Permit Amendment

T-13446

REFERENCE: Permit Amendment Application T-13446

In the Matter of Permit Amendment	)	FINAL ORDER
T-13446, Crook County	)	APPROVING AN ADDITIONAL POINT
	)	OF APPROPRIATION

Authorized and Proposed Points of Appropriation
Crook County Oregon

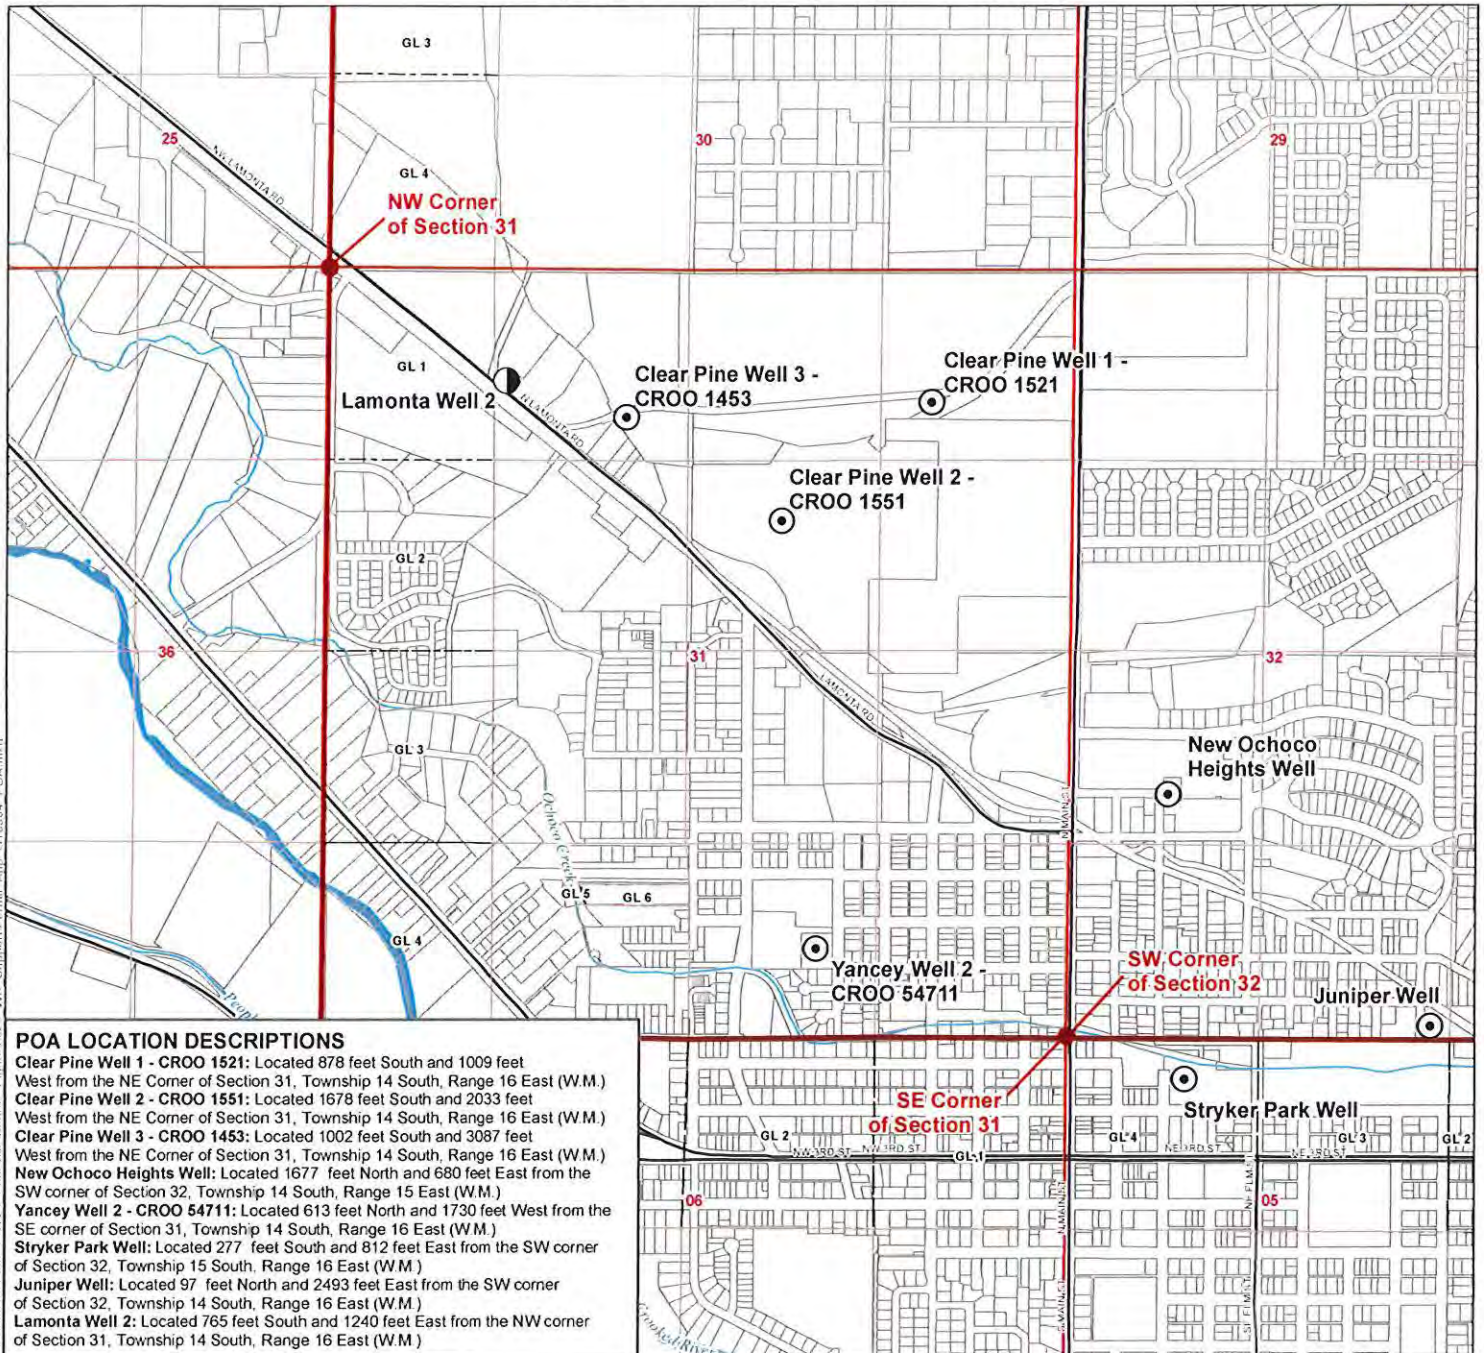
1. Table 1 of the application identifies the location of proposed point of appropriation Lamonta Well 2 as being in the SW SE of Section 31, T14S, R16E, WM. However, the application map identifies the location as being within the NE NW of Section 31, T14S, R16E, WM. Please verify the location of Lamonta Well 2, and revise either Table 1 or the application map, and resubmit.

Attached is a revised application addressing the deficiencies to Permit Amendment Application T-13446. Note that the proposed POA location has been amended in Table 1 of the application. Acknowledgment of the City's understanding of potential injury to their own water right was sent via email by Eric Klann, City of Prineville Engineer and Public Works Director (original message forwarded below).
